STAFF REPORT COMMUNITY DEVELOPMENT DEPARTMENT

HEARING DATE: 6/15/2021
TO: Mayor & City Council
FROM: Sonya Allen, Associate Planner
208-884-5533
SUBJECT: FP-2021-0033
Midgrove Plaza
LOCATION: 1450 E. Franklin Rd., in the SE ¼ of
Section 7, T.3N., R.1E. (Parcel
#S1107449996)

Final plat consisting of 5 buildable lots on 12.84-acres of land in the C-G and I-L zoning districts.

PLAT SHOWING
MIDGROVE PLAZA

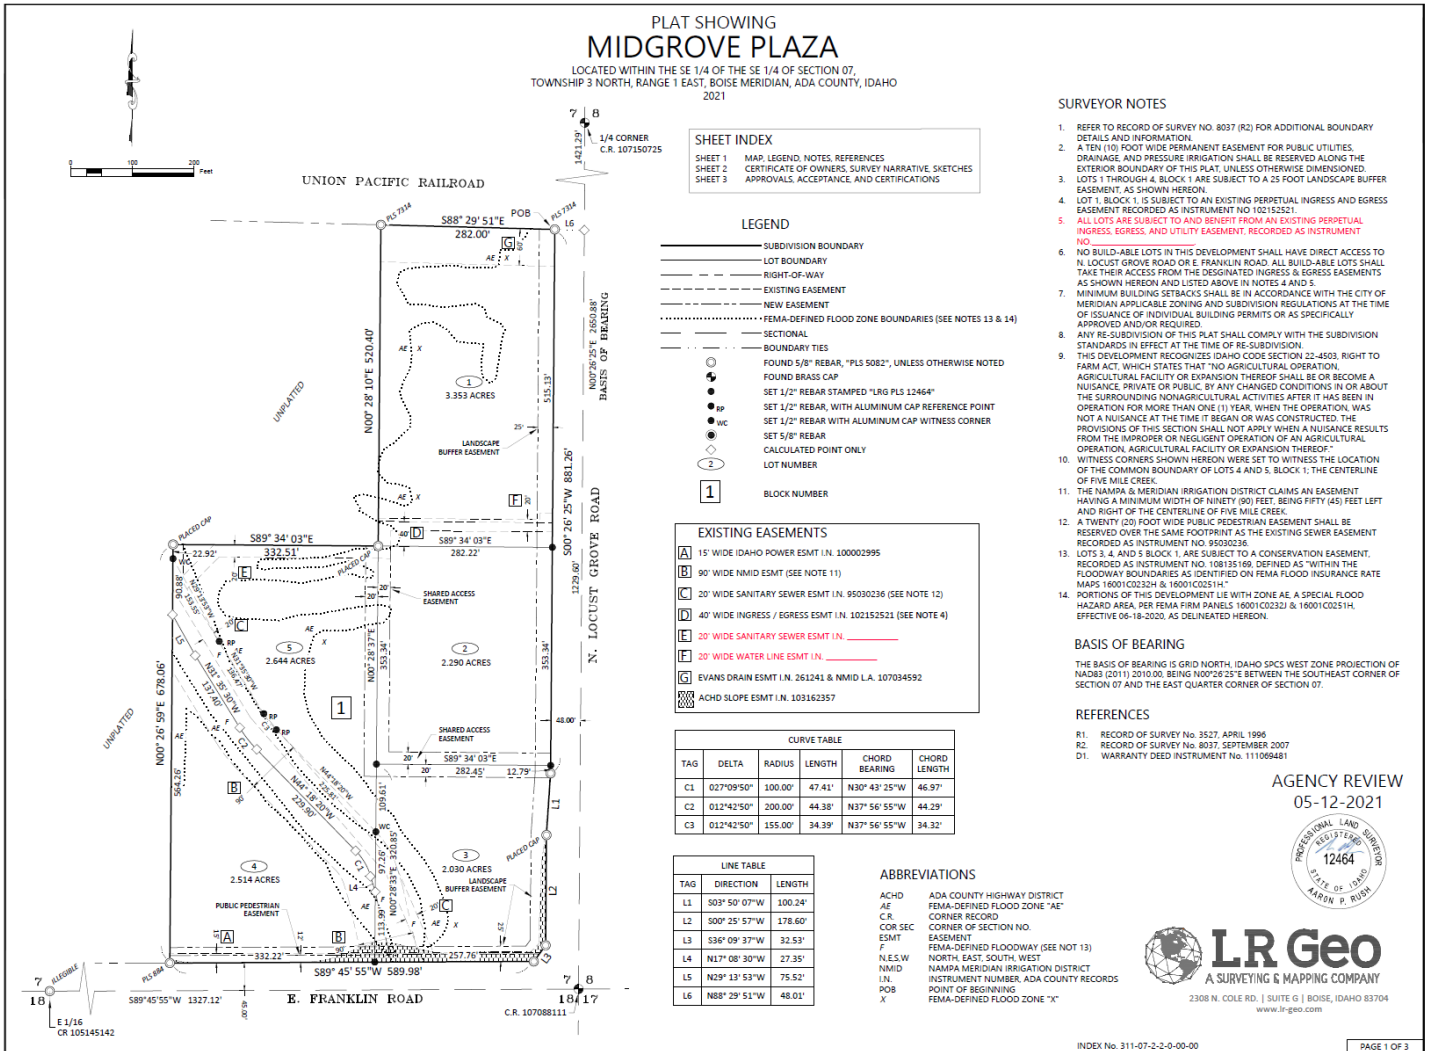
- a. Modify note #5 as follows: A cross-access/ingress-egress easement shall be depicted between all lots in the subdivision and to the abutting property to the west through Lot 5 (Parcel #S1107449111) in accord with UDC 11-3A-3A.2.

- b. Modify note #6 as follows: Include a note that prohibits direct lot access via N. Locust Grove Rd. and E. Franklin Rd. other than those accesses approved with the preliminary plat by the City and ACHD.

- c. Existing Easements Table – "E" and "F": Include recorded instrument numbers.

An electronic copy of the revised plat shall be submitted to the Planning Division prior to signature on the final plat by the City Engineer.
